DEPARTMENT OF THE CHIEF MECHANICAL ENGINEER (ROAD SERVICES)
L. T. E. CHISWICK WORKS, LONDON, W.4.

PROCESS SPECIFICATION	TITLE	PART No
PT.6	REINFORCING PLATE - FRONT BOTTOM PANEL	RT.324.E2

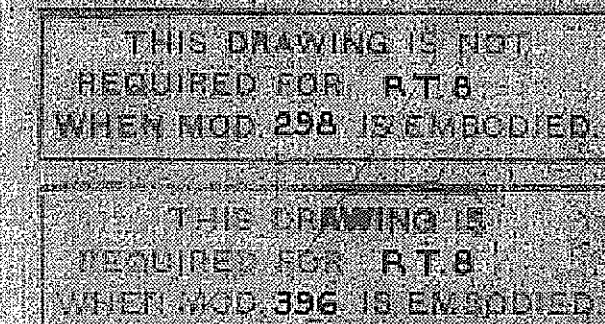
30578 (4) (AUG. 1970 - C)	<p>ALTERATIONS</p> <p>ISSUE 2</p> <p>NOTE RE. MOD. 208 ADDED</p> <p>ISSUE 3</p> <p>3/4" DIA. HOLE BELIEVED TO BE FROM TOP OF PLATE WITH 4" DIM. NOTE, 45 HOLES 3/4" DIA. HOLE WAS 24 HOLES EXTREME OF 1/4" DIA. HOLE OF BOTTOM 4" GROUP. C5K WAS NOTE 4 HOLES - C5K WAS 2 HOLES NOTE THICKNESS WAS 1/8" NOW JARCE</p> <p>ISSUE 4</p> <p>HOLES OF COWL ARCH WAS 4 DIMS. WAS 1/8"</p>
------------------------------	---
